ADDRESS: 4340 GLENDALE

APPLICATION NO: HDC2025-00116

HISTORIC DISTRICT: RUSSELL WOODS-SULLIVAN

SCOPE: REPLACE WOOD WINDOWS WITH ALUMINUM-CLAD WOOD WINDOWS

Pictures of the garage which depict work undertaken in 2024 by previous owner. Note that pictures of the full facades of the garage so it is unclear to staff if other unapproved work was taken at the garage

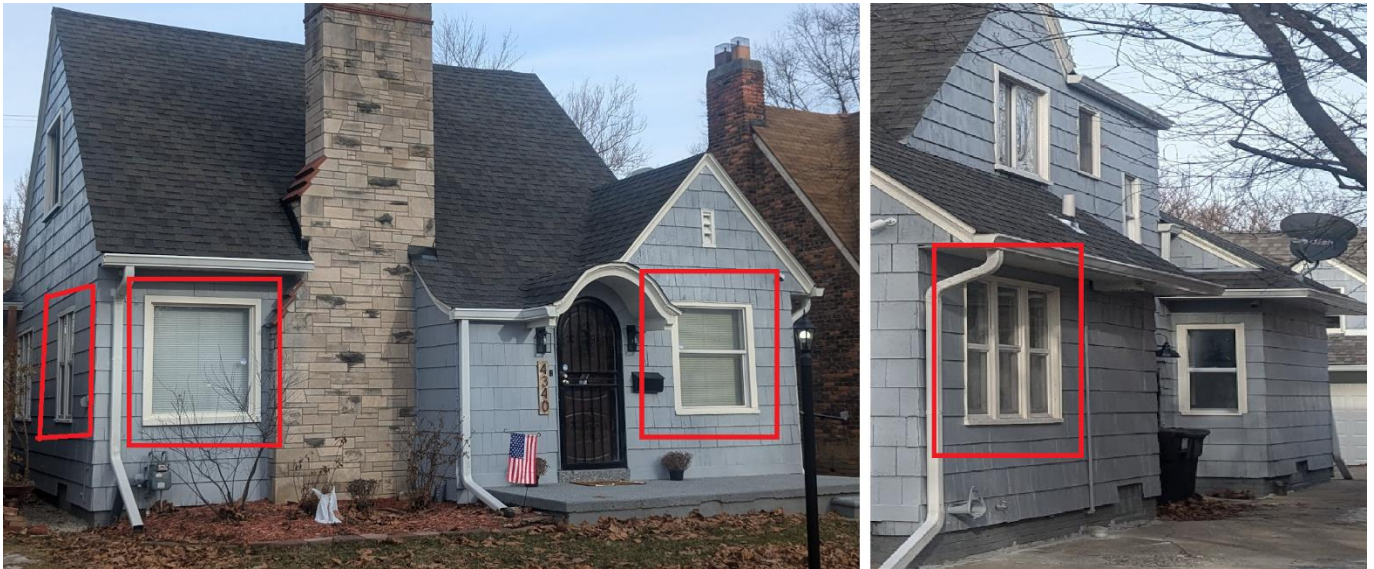
- With respect to the work proposed for the garage staff does note that the applicant is seeking approval to retain the unapproved vinyl slider window and removal of one window. It is staff's opinion that the vinyl slider windows are not appropriate to the building's historic character for the following reasons:

- They do not adequately resemble the historic units in terms operation.
 - Vinyl windows are not appropriate replacements for wood sash windows, due to their synthetic appearance and poor durability

Finally, staff notes that the window opening proposed for removal and enclosure at the garage wall is not visible from the public right-of-way. However, it is staff's opinion that the proposed enclosure of the opening with plywood is not an appropriate long-term treatment for the opening because plywood panel is not compatible with garage's existing siding and/or historic appearance. Rather, the opening should be enclosed with wood shake to match the adjacent siding.

- The vinyl slider window which was installed at the garage without HDC approval is not appropriate to the building's historic character.
- The proposed enclosure of an existing window opening at the garage with plywood is not an appropriate long-term treatment because plywood panel is not compatible with garage's existing siding and/or historic appearance. Staff recommends that the opening be infilled with wood shake to match the adjacent siding **should the Commission approve this work item**

Front façade. Two (2) sets of paired 4/4 double-hung windows with factory mull to be installed. Existing wood trim will be retained

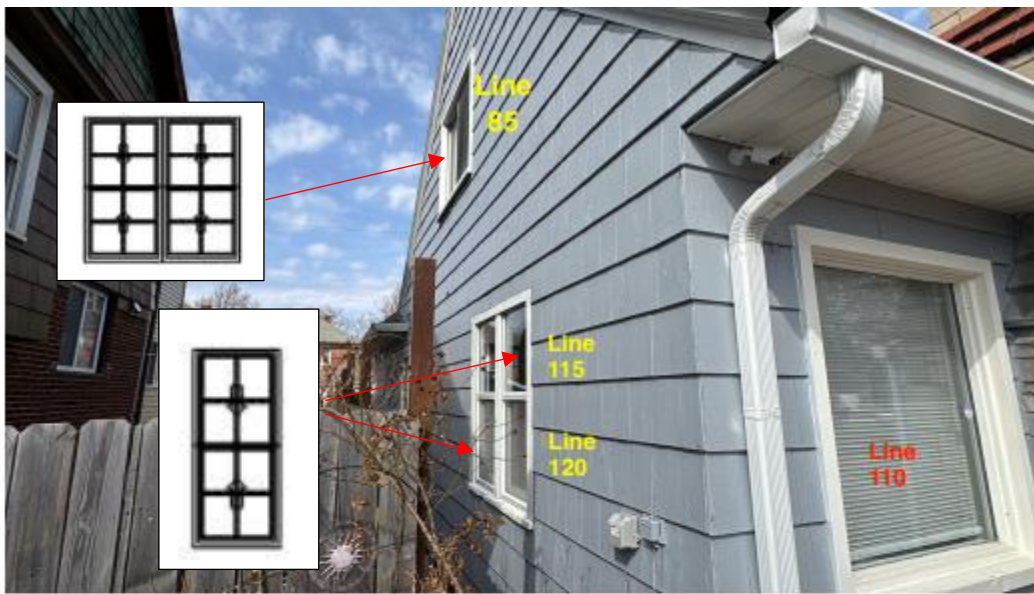
- It is staff's opinion that the proposed factory mullions do not adequately replicate the profile, width and depth of historic mullions. Staff therefore recommends that true wood mullions which match the existing be installed where missing at paired windows.

- The removal of the distinctive, character-defining original windows and trim does not meet the Standards.
- Factory mullions do not adequately replicate the profile, width and depth of historic mullions. Staff therefore recommends that true wood mullions which match the existing be installed where missing at paired windows **should the Commission approve this application.**
